Historic Architectural Review Commission

Staff Report Item 2

Meeting Date:	October 28, 2014
Applicant:	Stefano de Luca, Architect
Application Number:	H14-01-1351
Address:	#500 Duval Street
Description of Work:	Renovation of storefront windows. New egress door and fire safety equipment at Old Kress Building.
Building Facts:	<p>The historic building is listed as a contributing resource. The two story masonry vernacular structure was built in 1918. The building is located on the south west corner of Duval and Fleming Streets. The structure will be converted into a CVS Store. The historic Kress signs will not be altered or removed.</p> <p>In October 23, 2012 the Commission approved plans for revisions to the first floor façade in order to match original openings. The design was never executed.</p>
Guidelines Cited in Review:	Commercial Storefronts and Signage (page 46), specific guidelines 1, 2 and 5.

Re: **HARC Certificate of Appropriateness**
CVS #10169
500 Duval Street
Key West, FL 33040

1 SCHEME-1 FRONT ELEVATION (NORTH)
SCALE: 1/8"=1'-0"

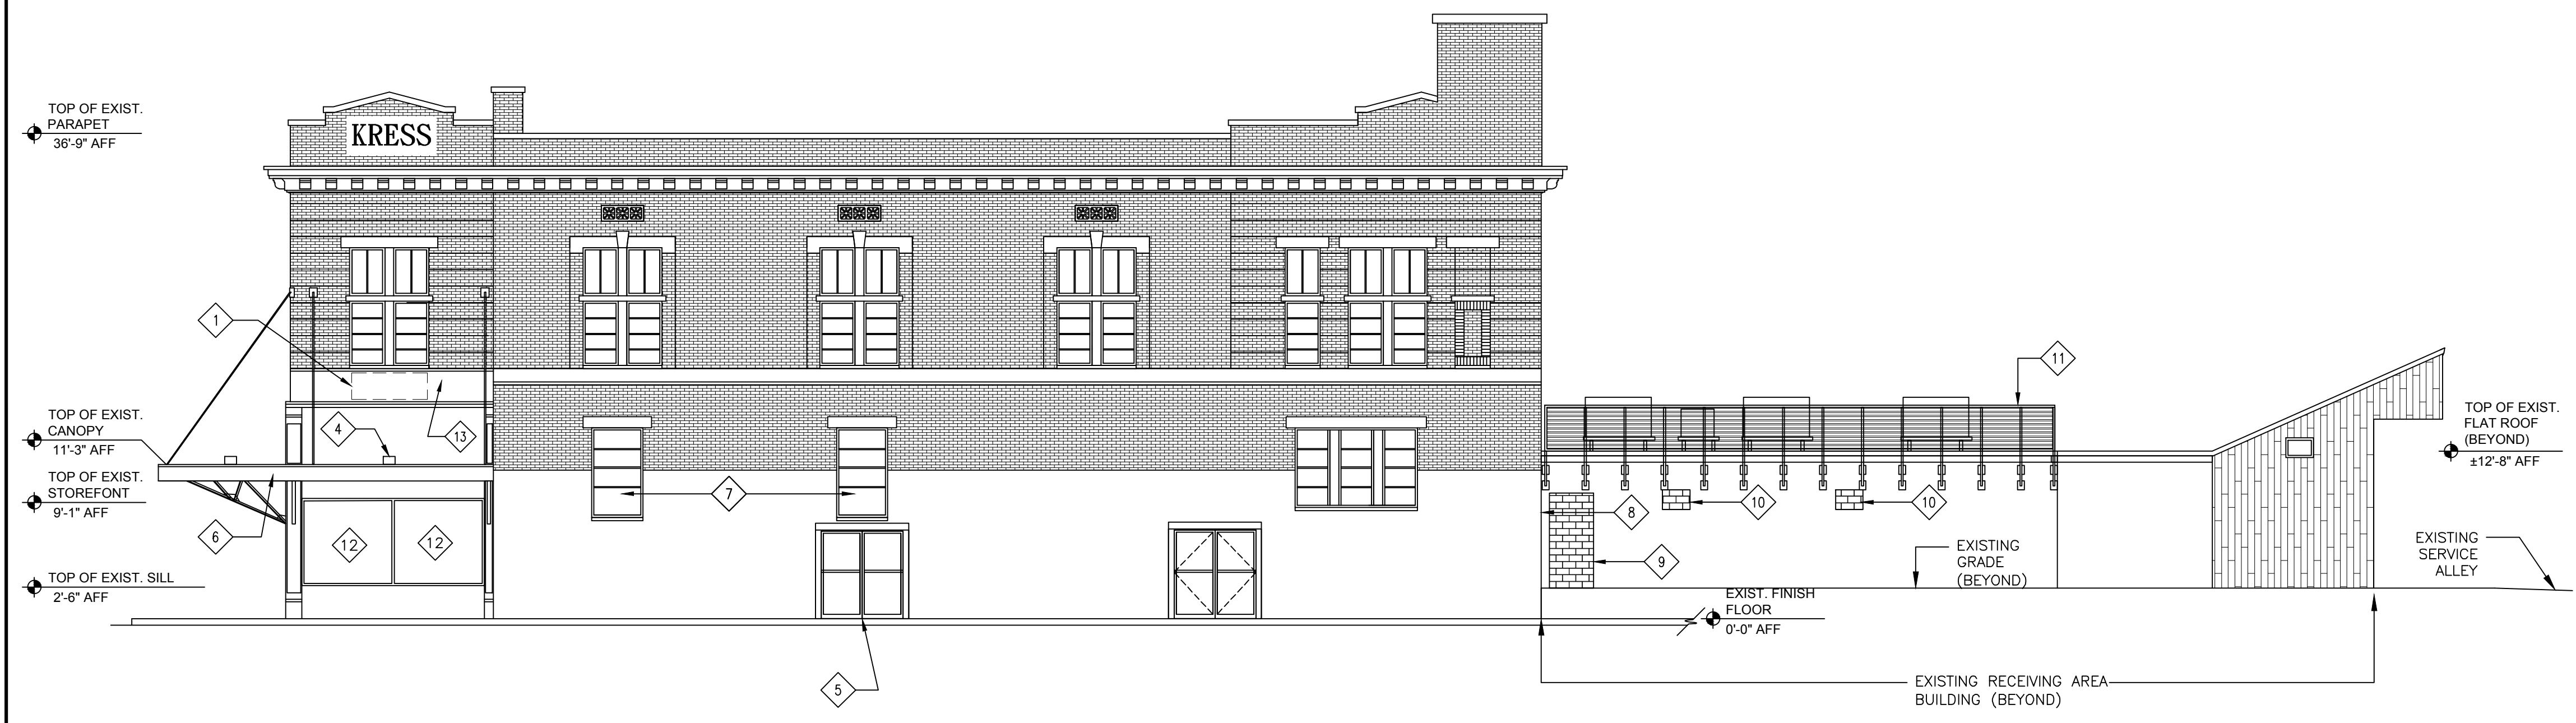
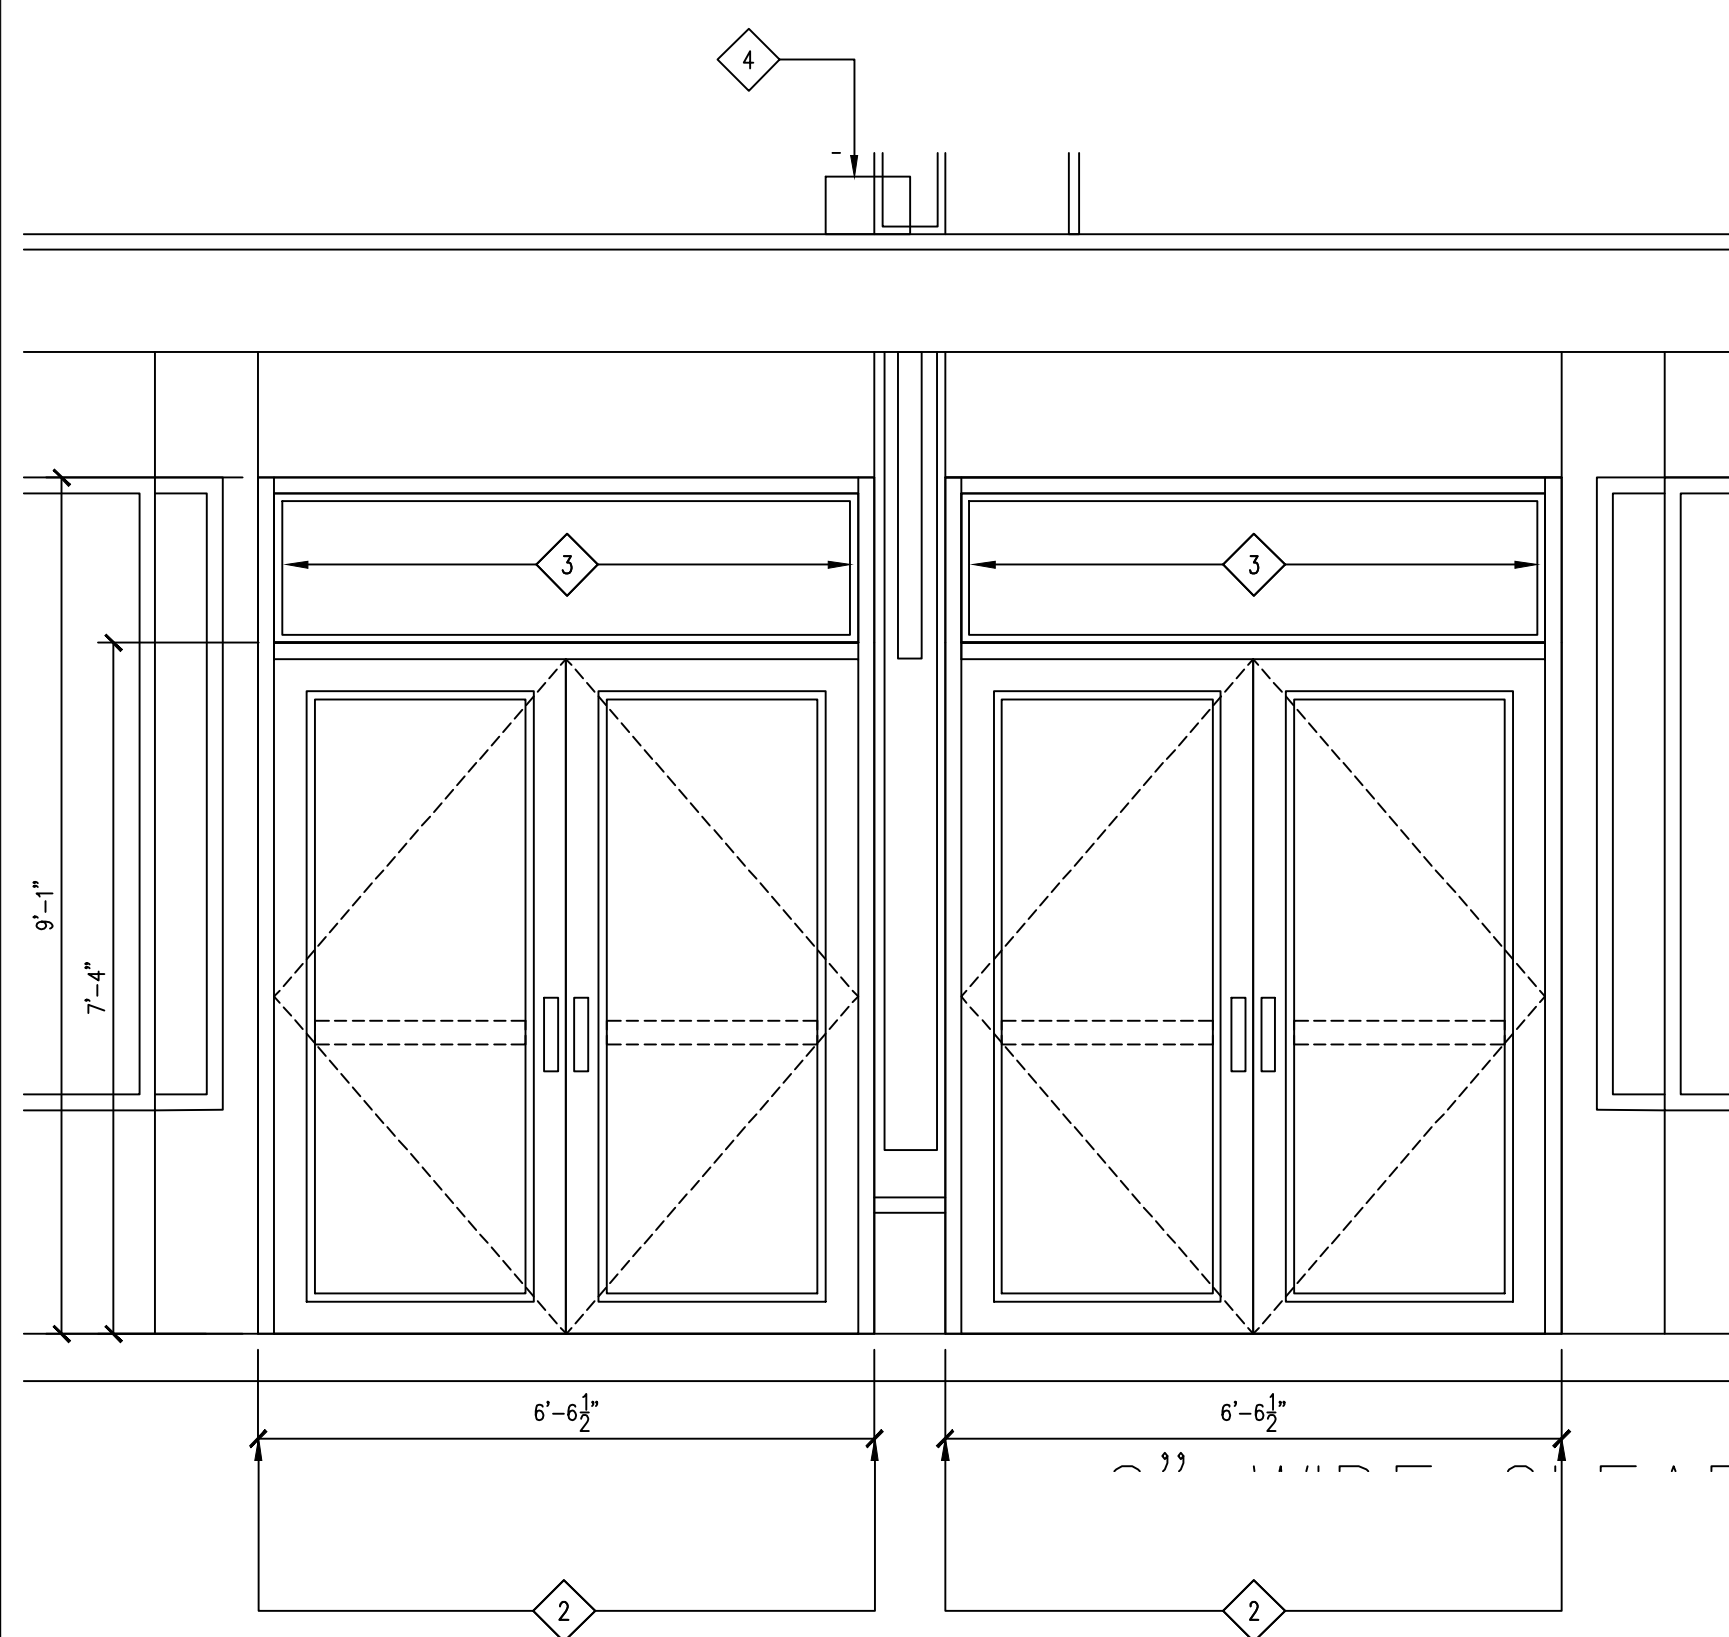
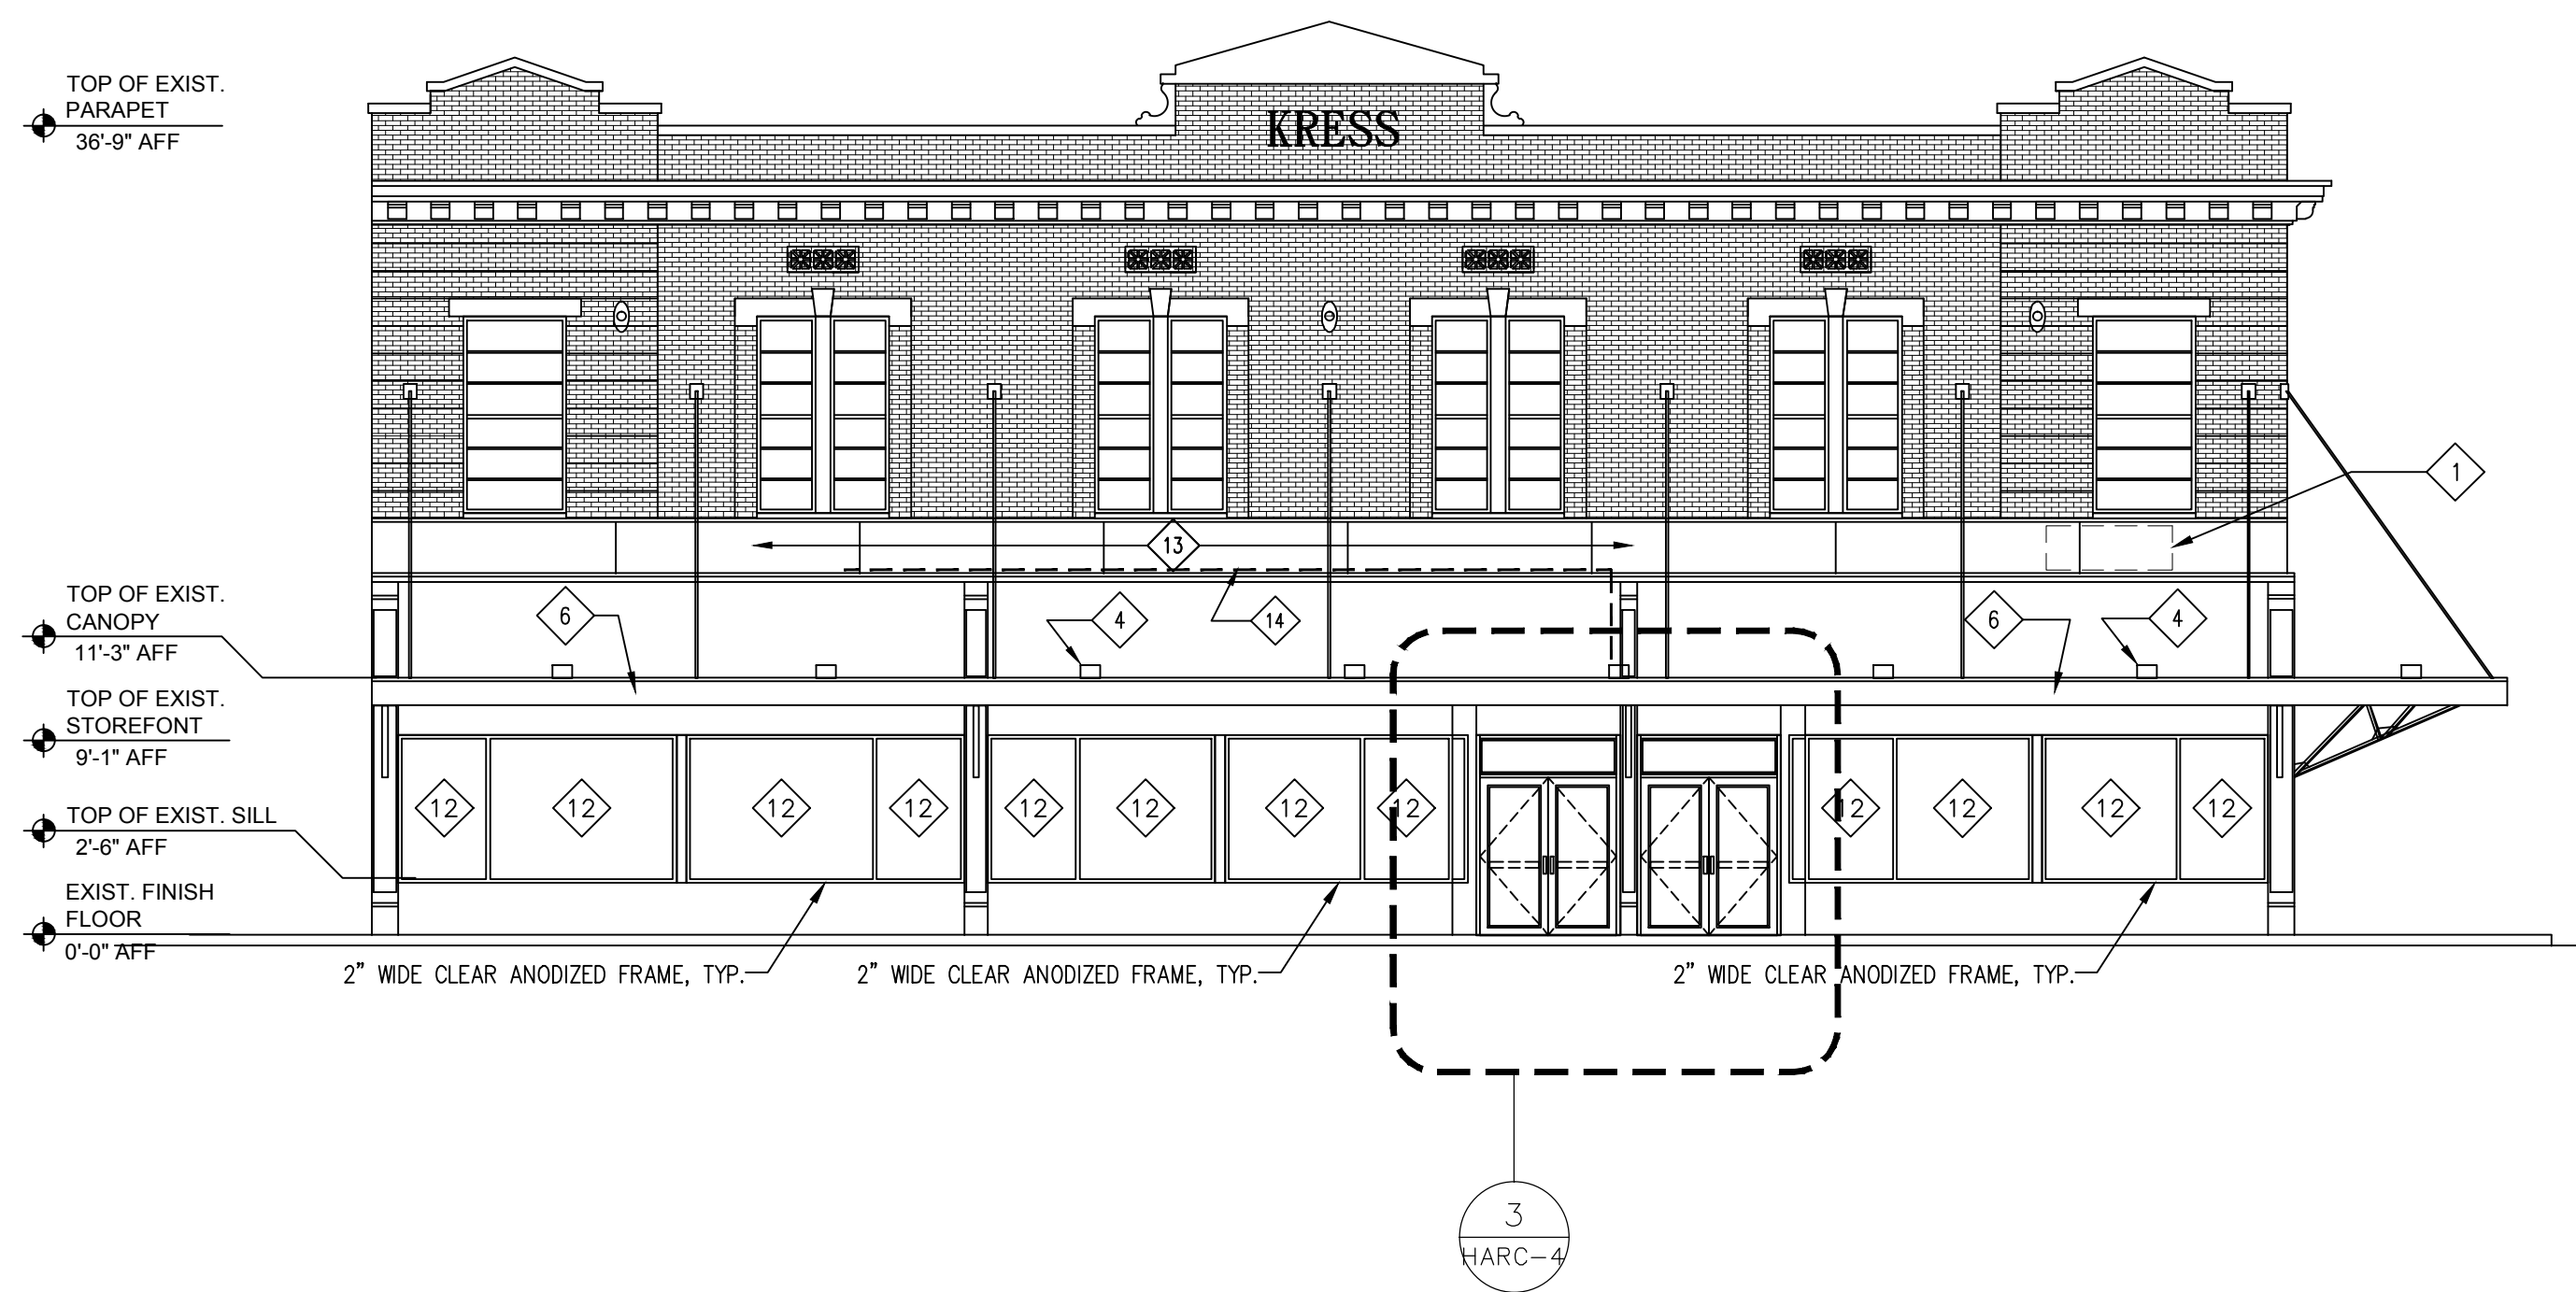
Scheme 1-Current single panels of glass on Duval Street will be split into two equal panels of glass. The Fleming storefront will be replaced to match existing number and size of panels.

1. Scheme #1 – the current single panes of glass on the Duval elevation will be split into two equal panes of glass. The Fleming storefront will be replaced to match existing number and size of panes of glass.
2. Scheme #2 – the current single panes of glass on the Duval elevation will be split into two, unequal panes of glass, approximately 4' and 8' wide. The Fleming storefront will be replaced to match existing number and size of panes of glass.
3. Scheme #3 – the current single panes of glass on the Duval elevation will be replaced with similar sized glass panes after widening the existing columns as shown. The Fleming storefront will be replaced to match existing number and size of panes of glass.
